Appl. No. 10/611,332 Amdt. dated November 11, 2005 Reply to Office action of August 11, 2005

Amendments to the Drawings:

Inventor: F. Azzarello Sheet 1 of 2 Docket No.: USCC 8057US PLASTIC CONTAINER WITH INTEGRAL 8AIL Attorney: Jonathan P. Soifer (314)238-2400 ANNOTATED SHEETS SHOWING CHANGES

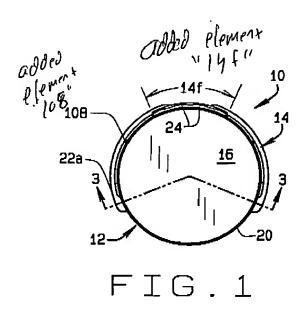
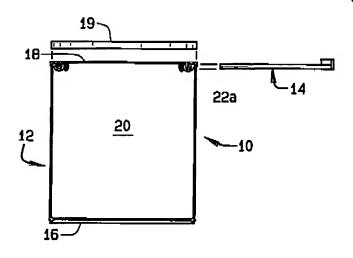
The attached two (2) sheets of drawing includes changes to Fig. 1 and Fig. 6. The sheet for Fig. 1, which includes Figs. 1, 2 and 4, replaces the original sheet. In Fig. 1, tabs are denoted "108" and element "14b" has been revised to element "14f". The sheet for Fig. 6, which includes Figs. 5-8, replaces the original sheet. In Fig. 6, previously omitted element "14d" has been added. Also, attached are two annotated sheets of drawings shown the changes made to Figs. 1 and 6.

The Examiner objected to the drawings because the subject matter to claims 6, 9 and 25 are allegedly not clearly disclosed in the drawings. The Examiner contends that the upper end ring's flange wherein the flange prevents the bail from returning to its original position is not clearly disclosed in the drawings. Fig. 3B clearly discloses the upper ends ring's flange as "15f". As such, Fig. 3B is not being re-submitted. Applicant is submitting new Fig. 1 wherein new Fig. 1 denotes the tabs as "108" and element "14b" has been revised to element "14f". Applicant is submitting new Fig. 6 wherein new Fig. 6 denotes the channel as "14d".
